Hamden Road Safety Audit

Route 707 (Whitney Avenue): Hamden / New Haven
Town Line to Millbrook Road

Exhibit 20: Bicyclist Traveling Northbound at Armory Street Intersection

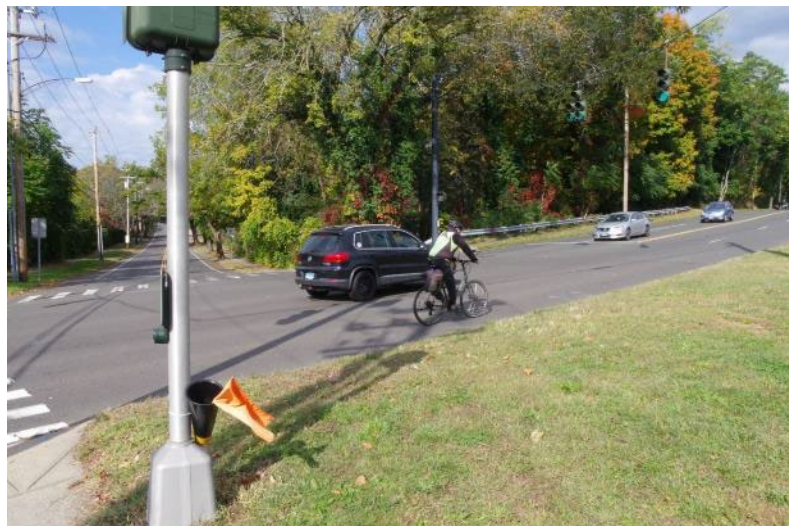
- The travel lane widths appear to be about 10.5 – 11 feet wide in this area. There is no shoulder. If a road diet were to be implemented in this area, bike lanes would likely be less than the five-foot recommended width. Exhibit 20 displays a bicyclist riding through the intersection.

- There is no crosswalk across the northern leg of the intersection. The crosswalk across the southern leg of the intersection has crossing flags, as shown in Exhibit 20.

Exhibit 25: Route 707 (Whitney Avenue) Preliminary Concept

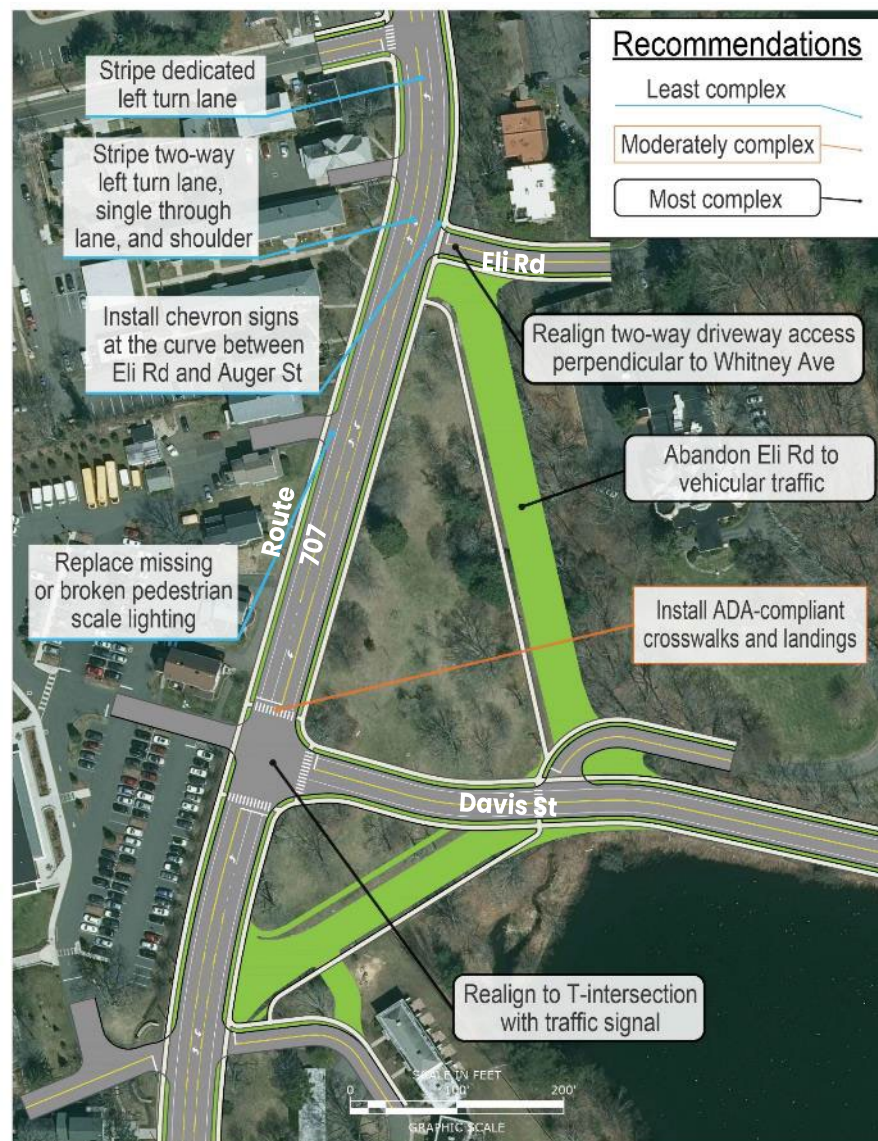
- There are no mid-block crosswalks.
- One participant observed southbound vehicles speeding.
- The crosswalk across Davis Street is faded.
- It is difficult for drivers to merge onto Route 707 (Whitney Avenue) from Eli Road because of sightlines and skew of the intersection.

- The crossing distance across Eli Road is long. The driveway to Whitney Wood apartments, at the intersection of Route 707 (Whitney Avenue) and Eli Road has an awkward placement at (or in) the intersection. Exhibit 21 displays this intersection and the extra pedestrian ramp that does not have a marked crosswalk.

Recommendations in this area focus on roadway lighting, school zone speed reduction, speed reduction at curves, and the realignment of the intersection at Eli Road, as displayed in Exhibit 25 and Exhibit 26. If Davis Street and Eli Road are realigned as show in Exhibit 25, significant impacts to Eli Whitney Park would occur, which could involve fulfilling Section 4f requirements. Exhibit 26 is an alternative concept and was developed to show reduced impacts to Eli Whitney Park.

- 1) Reconstruct Route 707 (Whitney Avenue) intersection in the Davis Street / Eli Road area, as displayed in Exhibit 23.

Location 4: Intersection Route 707 and Waite Street

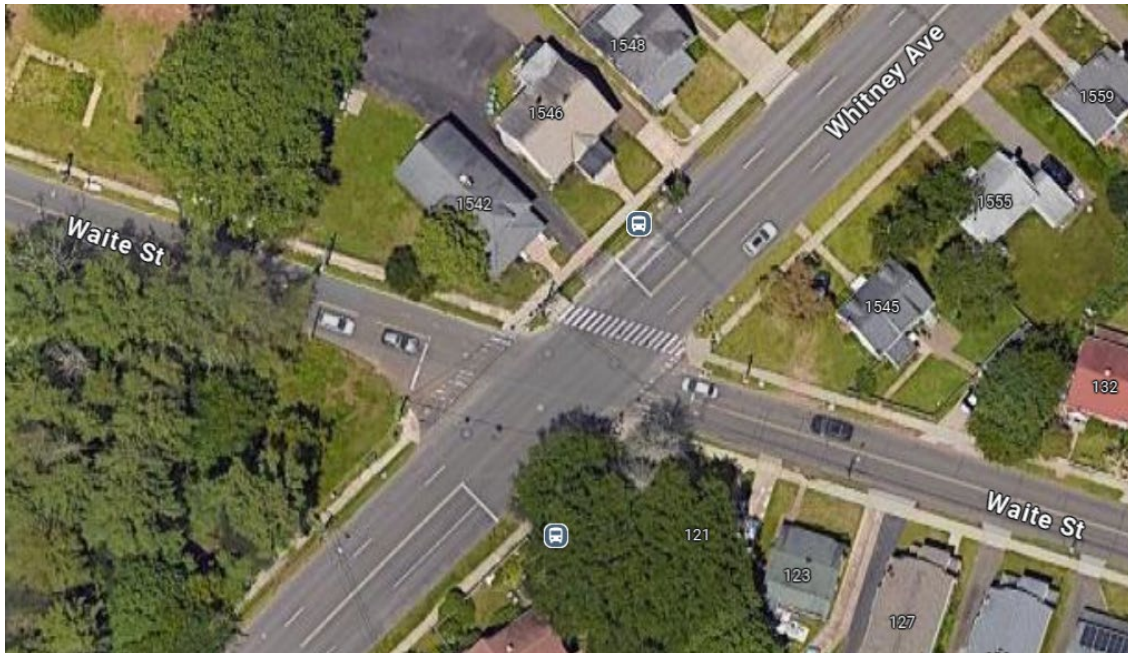
- This signalized intersection is askew and has poor sightlines because of a curve to the north of the intersection and grade/elevation change on the western leg of Waite Street.

- There is no pedestrian scale lighting.
- There is no street sign identifying Waite Street.
- There is no crosswalk across the southern leg of Route 707 (Whitney Avenue). The crosswalk across the western leg of Waite Street is faded.

- Higher than expected truck traffic on Putnam Avenue
- **Location 4: Intersection of Route 707 and Waite Street:**
 - Intersection is askew and poor sightlines due to grade change
